**South Walker Creek Mulgrave Resource
Access: Stage 2C (MRA2C)**

**Appendix I:
Groundwater Supplementary Memo**

To	John Kennedy	Company	BHP
From	Kathryn Rozlapa	Job No.	187C
Date	30/1/2019	Doc No.	021c
Subject	Response to IESC Review, Groundwater Modelling

FIGURE 1
MONITORING
SITES

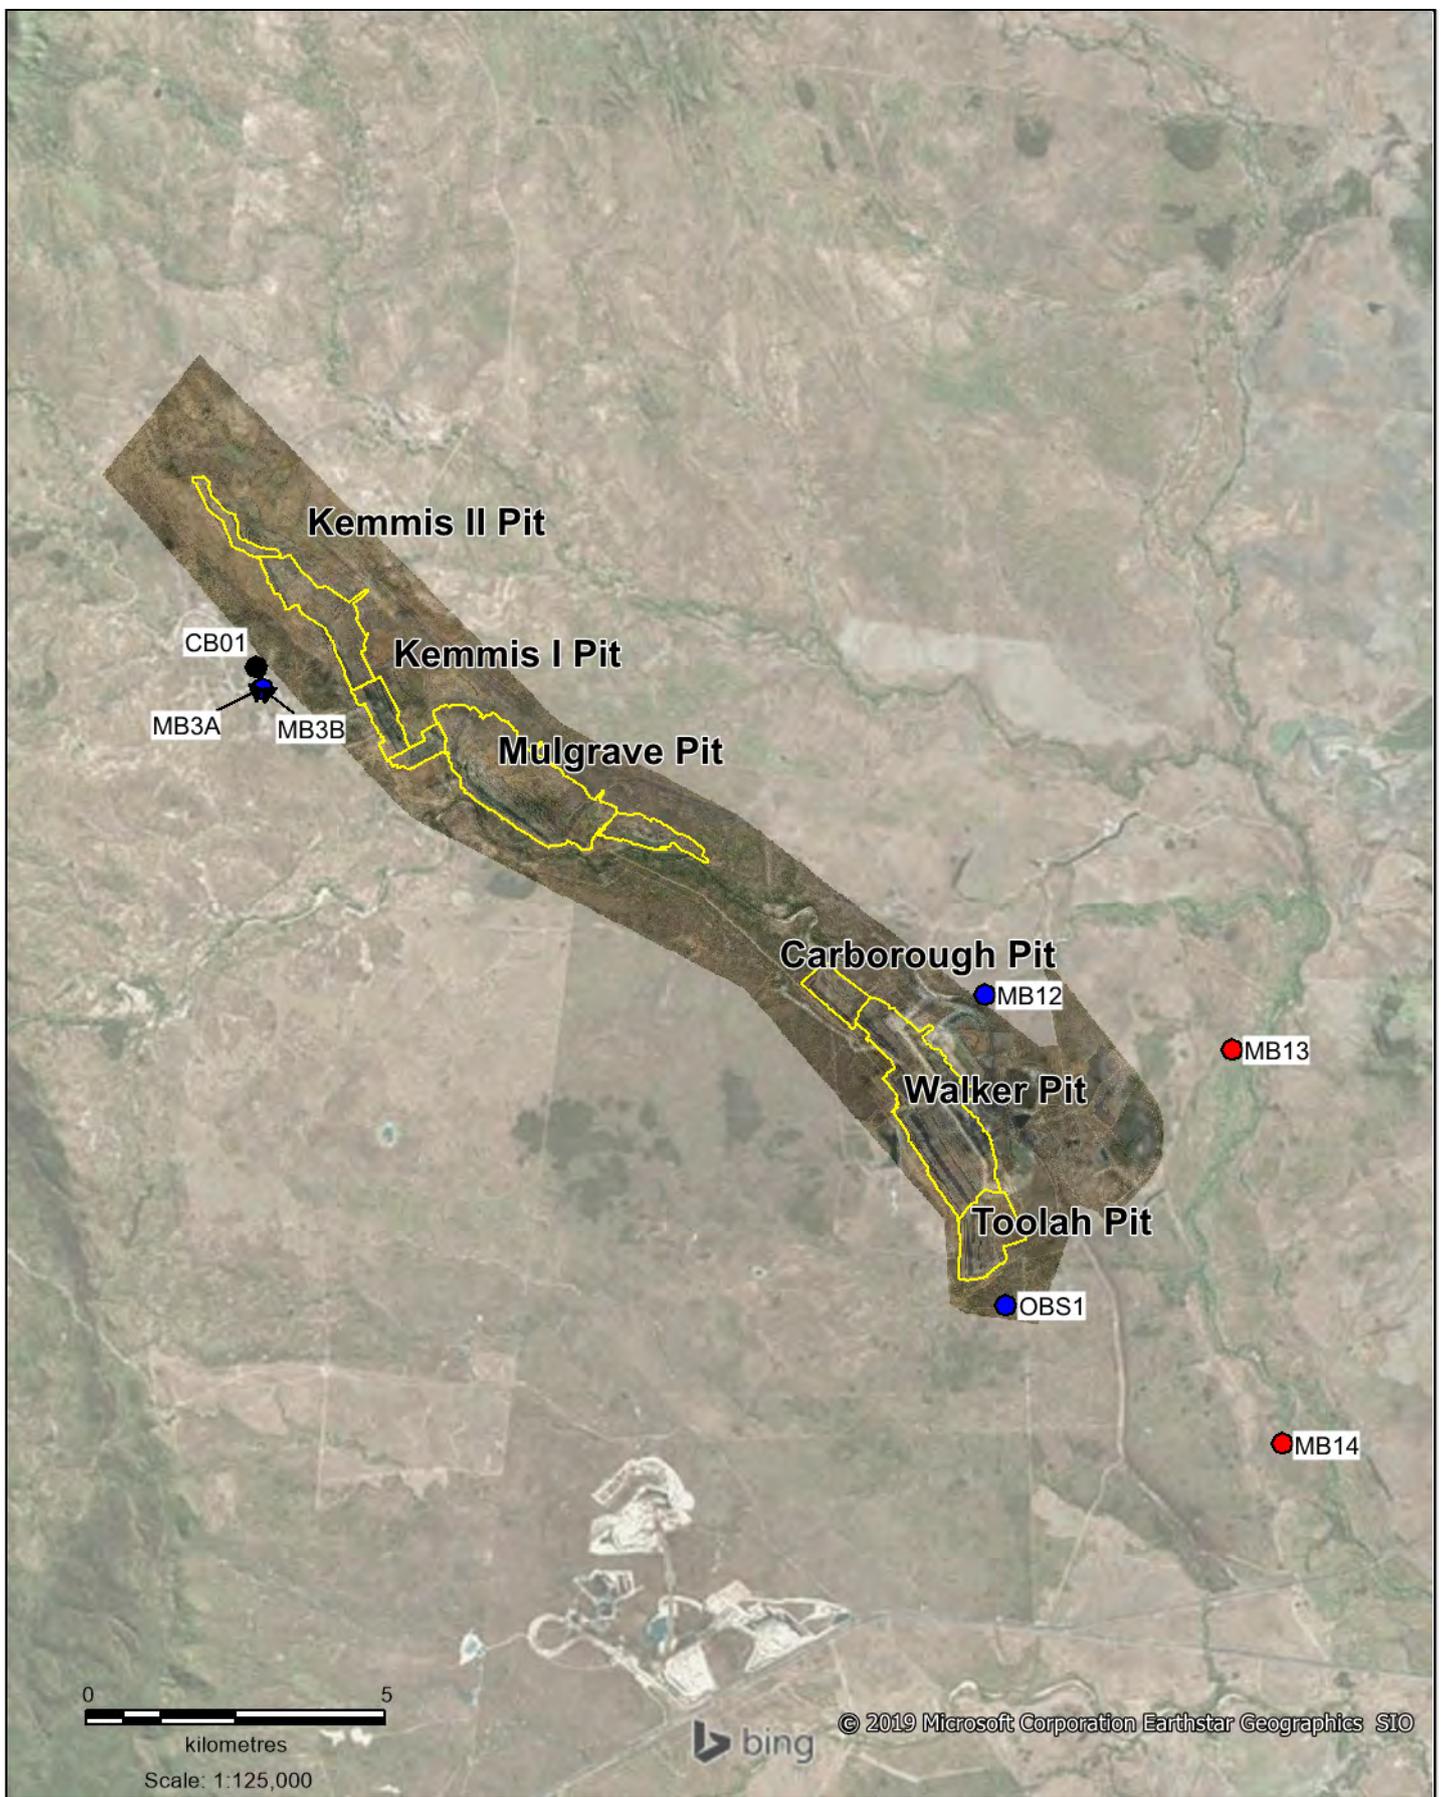
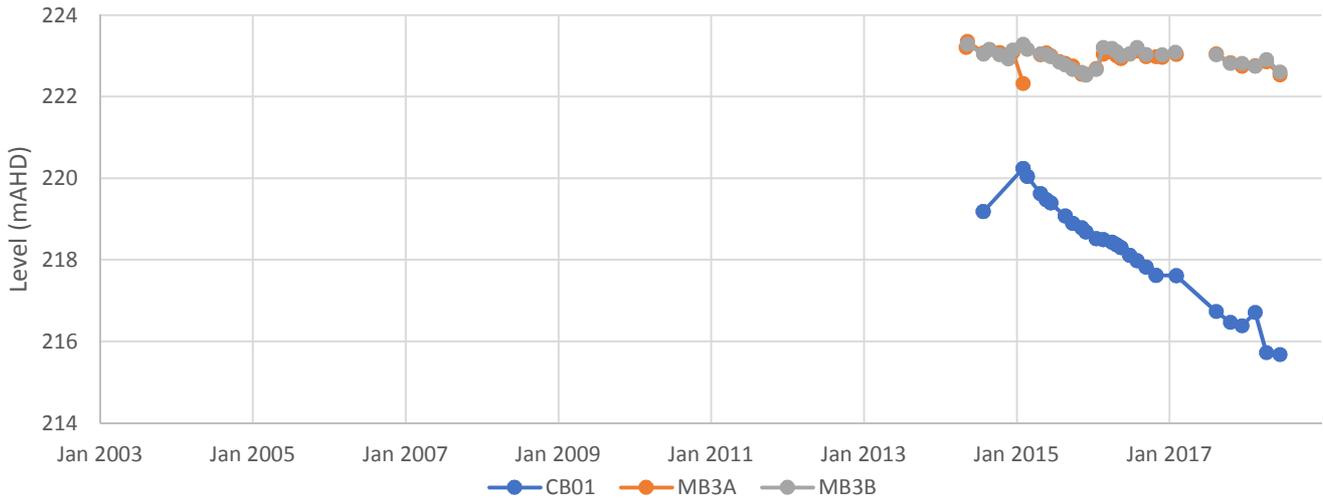
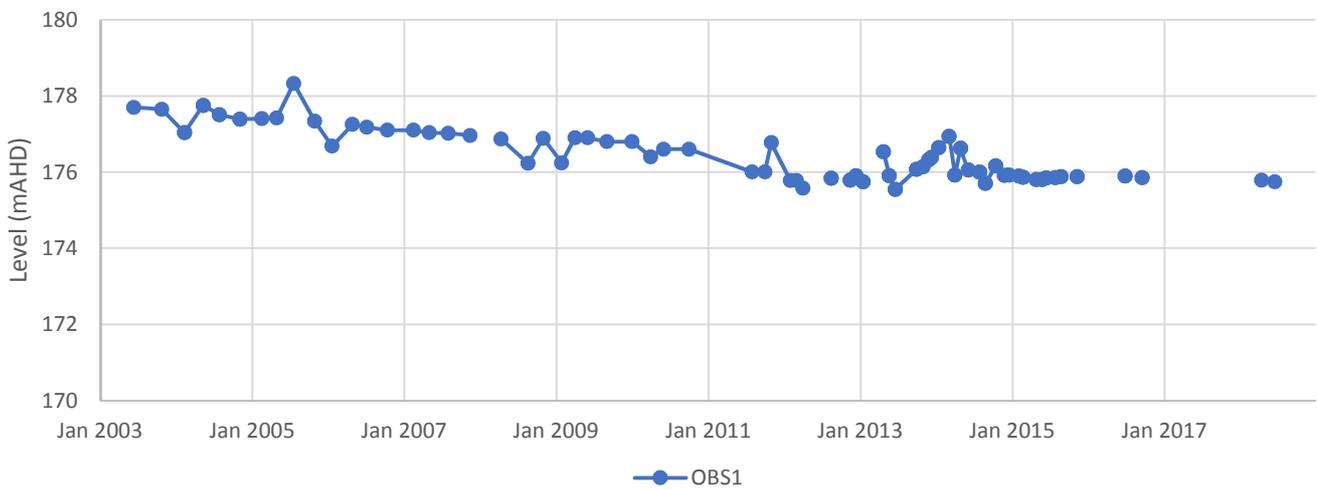
Mining at South Walker Creek (SWC) commenced in 1996. There are six existing pits at the SWC mine (Kemmis I and II, Mulgrave, Carborough, Walker and Toolah) as shown in Figure 1. A recent topographic survey of the mine area suggests that mining (until the time of the survey) had progressed to pit base elevations of between approximately 95 mAHD and 200 mAHD.

Monitoring at SWC is available since 2003, with the frequency of monitoring varying with location. Selected monitoring locations are shown in Figure 1 with monitoring at each location shown in Figure 2. While there is not sufficient monitoring to correlate all water level changes since the start of mining, the following trends are evident:

West of Kemmis Pit - CB01 (Coal Seam), MB3A and MB3B (Regolith)

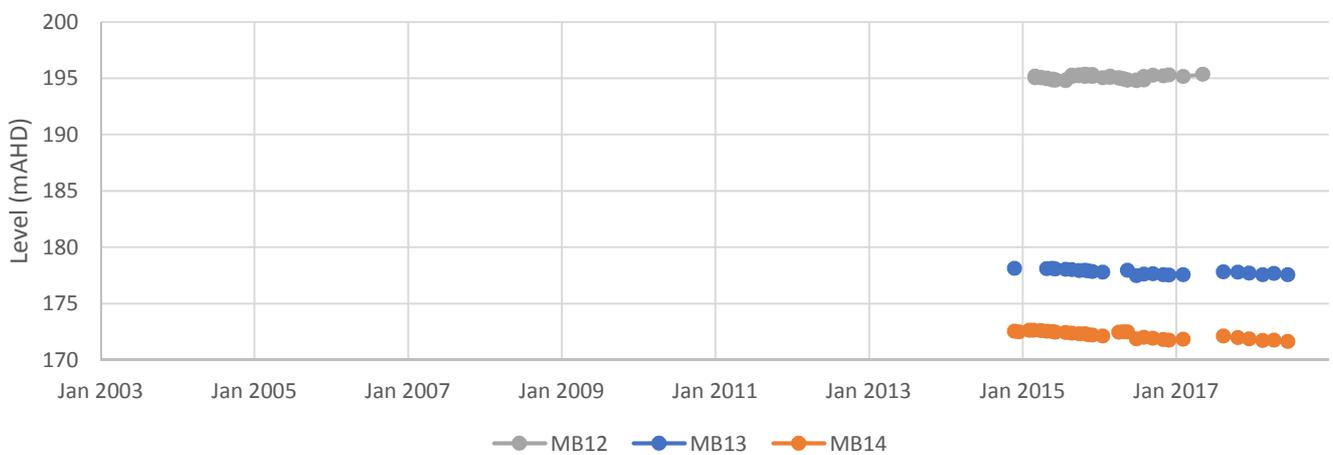
- Monitoring from the area west of Kemmis Pit is shown in Figure 2. Piezometric levels measured at CB01, located west of the Kemmis Pits, declined by almost 5 m between 2014 and 2018, to around 215 mAHD (CB01 is reported to be screened over the interval 100 to 105 mAHD). Mining at the Kemmis Pits has advanced to a minimum elevation of close to 180 mAHD, which is 35 m lower than measured water levels at CB01. At monitoring locations MB3A and MB3B, which are close to CB01 and monitor the shallower regolith, seasonal water level variations are observed over the same period, as well as a decrease in water level of 0.7 m (from May 2014 to June 2018). Water levels at MB3A and MB3B remain at close to 223 mAHD or 43 m higher than the minimum pit base elevation at Kemmis Pit, suggesting

- Mining at the Toolah Pit has progressed to a minimum elevation of 95 mAHD. Monitoring of OBS1, which monitors the regolith and is located just south of Toolah Pit (Figure 2), shows a decline in water levels from 2005 to 2016 of close to 2 m, to around 209 mAHD or close to 115 m higher than the elevation of mining.

- MB13 and MB14 are located 5 km to the east and south east of the southern mining areas of SWC respectively (Figure 2) and monitor regolith water levels. Measured water levels at MB13 and MB14 respond to seasonal recharge and show an overall reduction of 1 m over the period December 2014 to June 2018. Mining at the closest pits, Walker and Toolah Pits, have reached minimum elevations of 125 and 95 mAHD respectively. Water levels at MB13 and MB14 are around 80 m higher than the minimum mining elevation reached at Toolah Pit.

- MB12 is located 1.5 km east of Carborough Pit and is screened in the alluvium. MB12 is located closer to mining than MB13 and MB14 and shows no decrease in measured water levels over the period 2014 to 2017, however mining at the Carborough Pit has reached a minimum elevation of 180 mAHD which is significantly higher than the elevation of the Toolah Pit (95 mAHD). Water levels at MB12 are around 15 m higher than the minimum mining elevation at Carborough Pit. Due to the proximity of MB13 and MB14 to active mining, compared to MB12, the measured drawdown at MB13 and MB14 may be attributable to mining operations.

FIGURE 3
LAYER 4
HSU ZONES

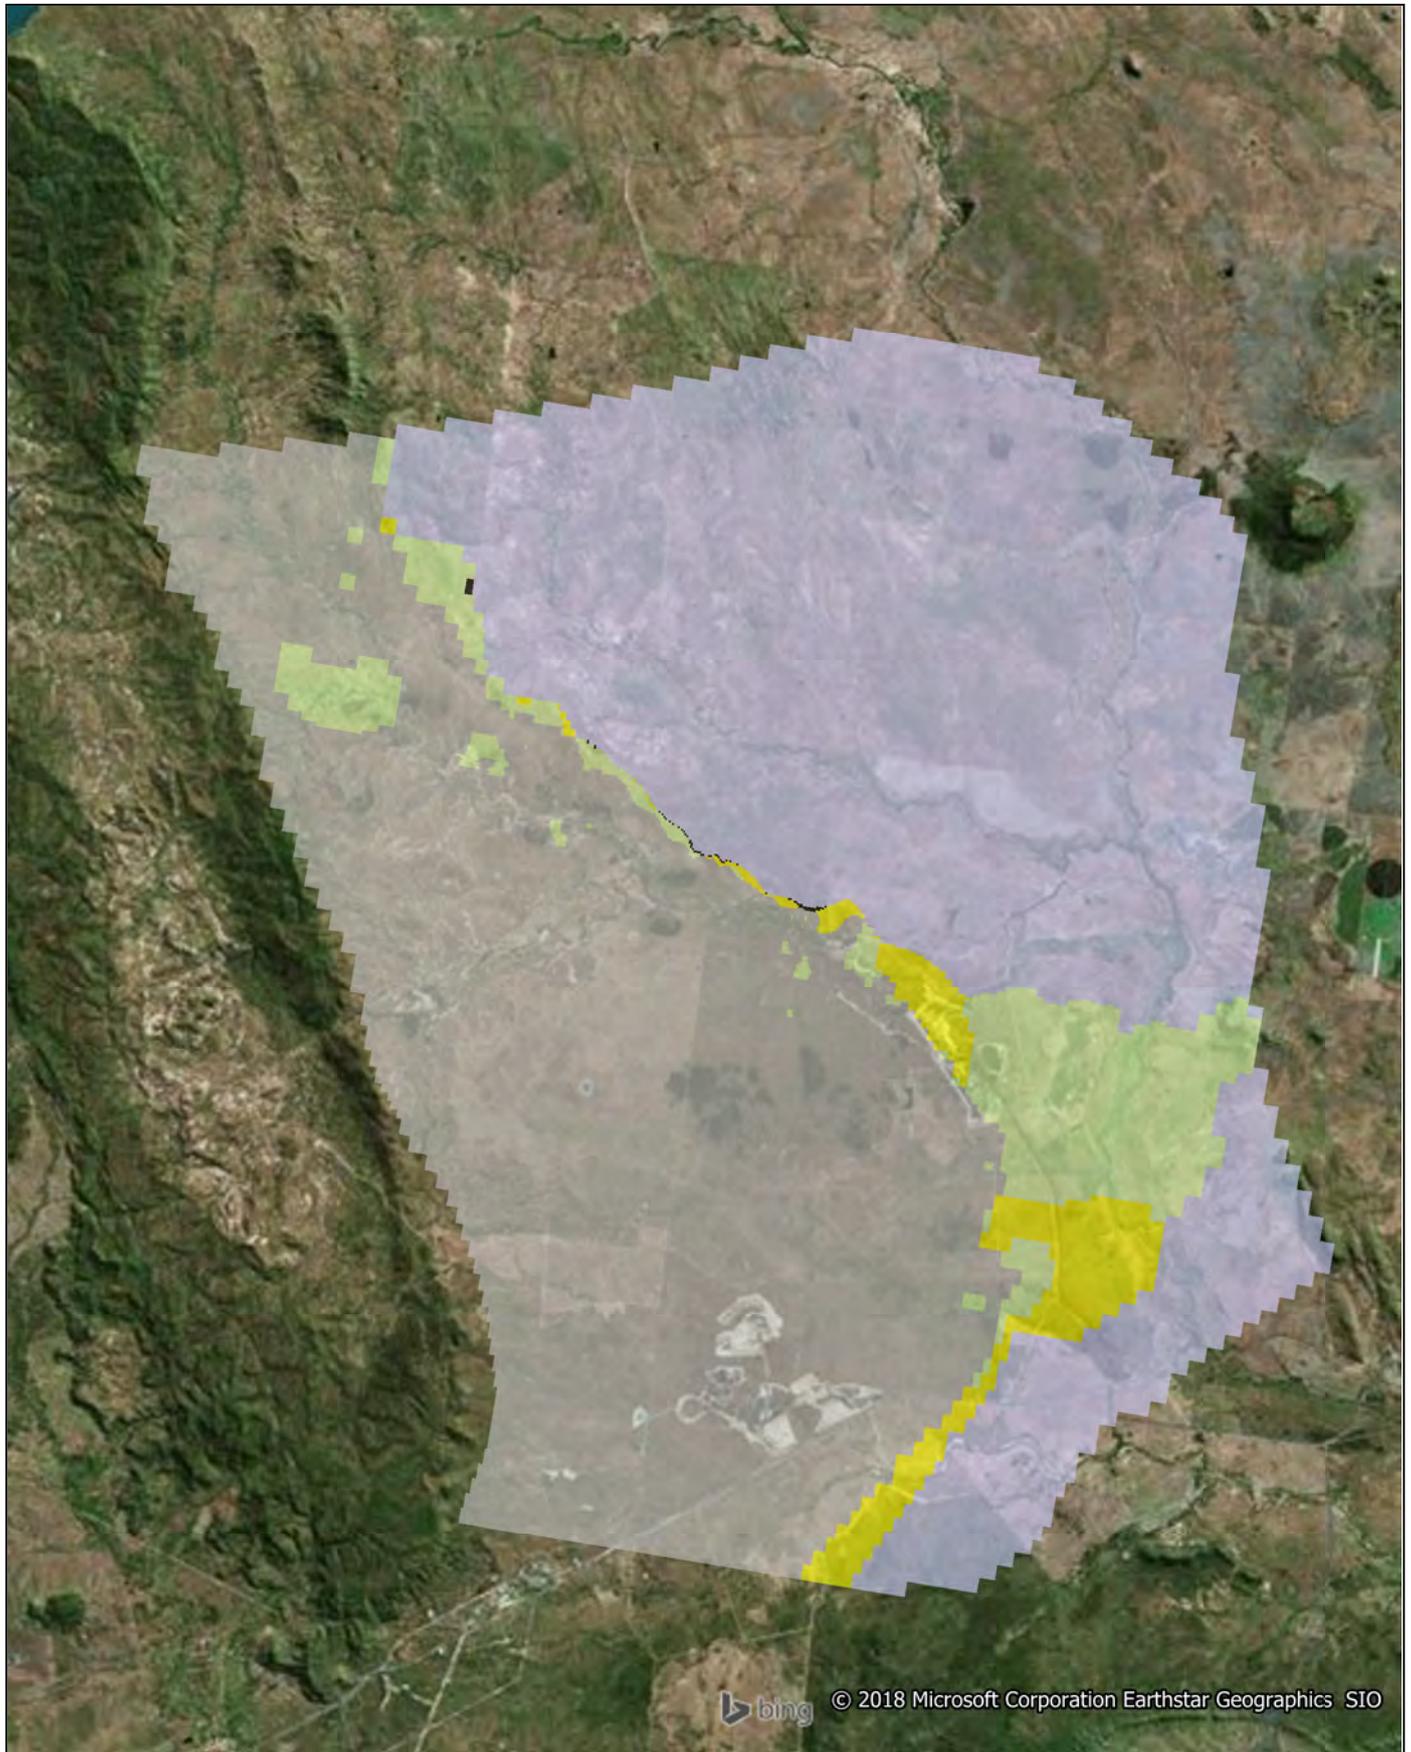
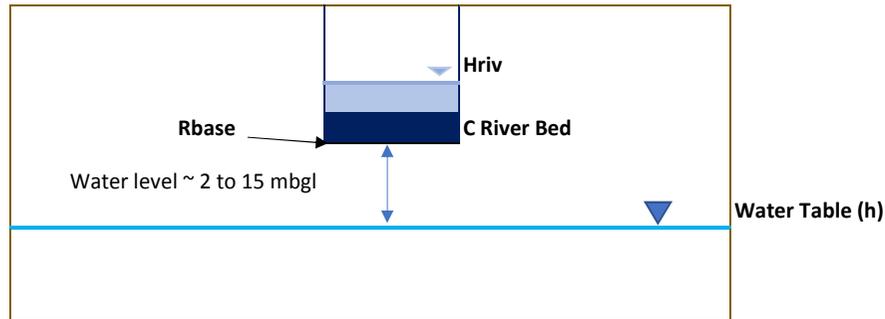
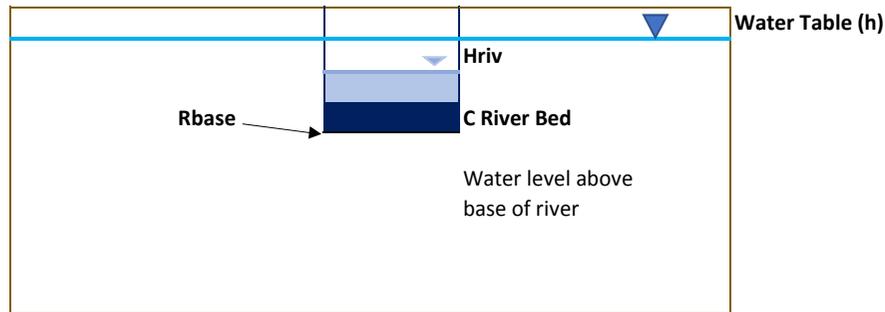
The pinching out of layers means that more than one HSU maybe represented by a single model layer. The HSUs for model layer 4 (or the confined aquifer shown in the Golder report), are shown in Figure 3. In general, the main coal seams are represented in the western portions of layers 4 and 6 (and small areas of layers 3 and 5). When drawdown is presented for the confined aquifer (layer 4), it is shown for the coal seam on the western side of the model domain, and the other HSUs included in layer 4, located on the eastern side of the model domain. The assignment of HSUs, by layer, are summarised in Table 1 below.

The approach outlined above is a standard one and is taken to represent layers which pinch out. The approach should not impact the results predicted by the model. A simple approach to limit the presentation of the extent of the predicted drawdown impacts within a layer would be to crop the contours of predicted drawdown to the extent of the modelled aquifer(s) of interest.

SCHEMATIC OF RIVER PACKAGE

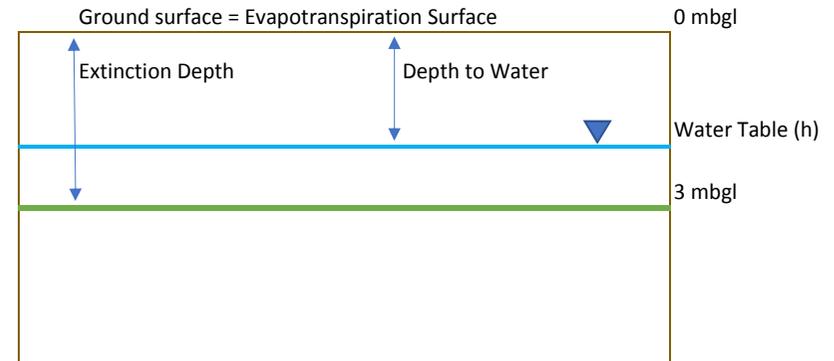
- The modelled creeks are assumed to be disconnected from the underlying groundwater (when flowing and when dry) and act as losing streams. The assignment of the RIV boundary condition to reflect this is shown in Figure 4 (Case A). This is consistent with monitoring bores located in the vicinity of creek lines which show a depth to water of between approximately 2 and 15 mbgl.

- River bed conductance is assigned consistent with the parameters shown in Figure 4 (K, L, W and m). The RIV package in the current model set up does not account for a significant increase in the depth of unsaturated material underlying the modelled creek. As a result, the model may under predict the time taken for leakage to a deeper water table, or over predict the time taken for river leakage to reach a comparatively shallower underlying water table.

- If groundwater levels are predicted above the base of the river, the flux from the underlying aquifer to the river is calculated by the difference between the aquifer water level and the assigned river stage (or head in the modelled river cell) as shown in Figure 4 (Case B). In all model output files inspected by AQ2, there was no leakage from the aquifer to the river (i.e. there was only leakage from the river to the underlying aquifer).

Groundwater outflow via evaporation from shallow water tables and evapotranspiration from vegetation is represented using the Evapotranspiration (ET) package in Modflow Surfact. The ET package uses a depth dependent relationship, such that if predicted aquifer water levels are at or above a specified elevation (represented by the ET surface), then ET occurs at the maximum specified rate. If predicted aquifer water levels decrease below the specified ET surface, the ET rate decreases linearly to zero as the predicted water level approaches an elevation equal to the ET surface minus a specified extinction depth. When aquifer water levels are below an elevation equal to the ET surface minus the extinction depth, the ET rate is zero. This relationship is shown schematically in Figure 4.
